Staff Report

REPORT NO.: DSD-2024-488

SUBJECT: Minor Variance Application A2024-098 – 153 Eighth Avenue

Figure 4 - Aerial photo from Google streetview.

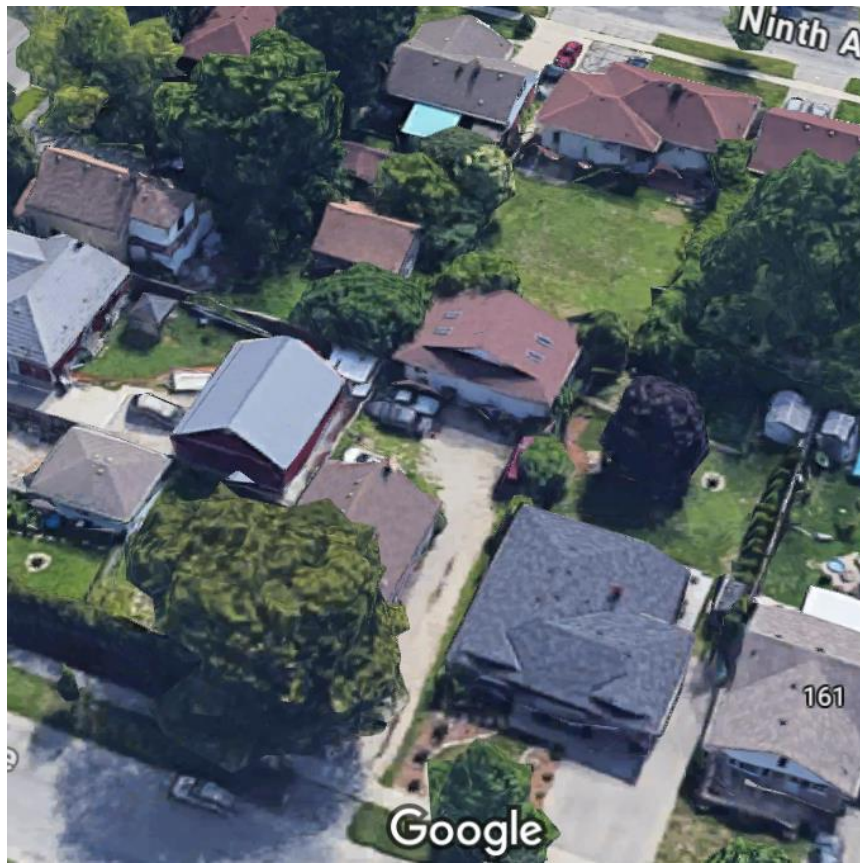
As shown in the drawings submitted with the application, the detached ADU is to be located in the existing garage which is located at the rear of the property and is shown on the drawings to meet the minimum 0.6 metre side yard and rear yard setbacks. As well, the minimum 5 metre setback to the main dwelling is met. The building already exists and permitting an increase of 3.7 m is considered minor (see Figure 4).

Figure 5 - Proposed zoning plan submitted with Zoning Certificate and this application.

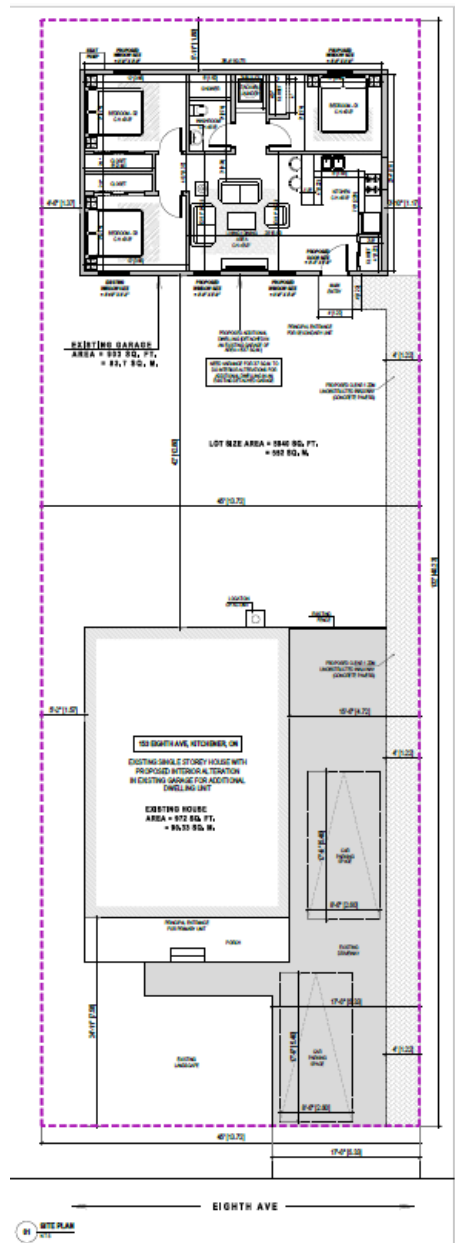
It was noted from the site visit, there is an additional existing deck/porch behind a fence in the front yard that is not shown on the zoning plan.

The deck is permitted provided it is less than 1 metre in height above the grade, is located 3 metres from the front lot line and 1.2 metres from the side lot line. The applicant will have to provide these details on the zoning plan and if regulations not met, the deck to be removed, reconstructed to comply, or consideration of a new minor variance application required.

In addition, there is a 1.5 metre high solid wood fence in the front yard not shown on the zoning plan. Whereas the maximum fence height in the front yard is 0.9 metres if the deck/porch it surrounds it is 0.6 metres high or less. The applicant has been advised that these details to be supplied on the zoning plan to determine maximum height of fence. If the fence is not permitted, then a separate Fence Variance Application is required to be considered or the fence could be removed or reduced in height to comply. Staff will work with the applicant on his zoning plan to ensure this item is resolved.
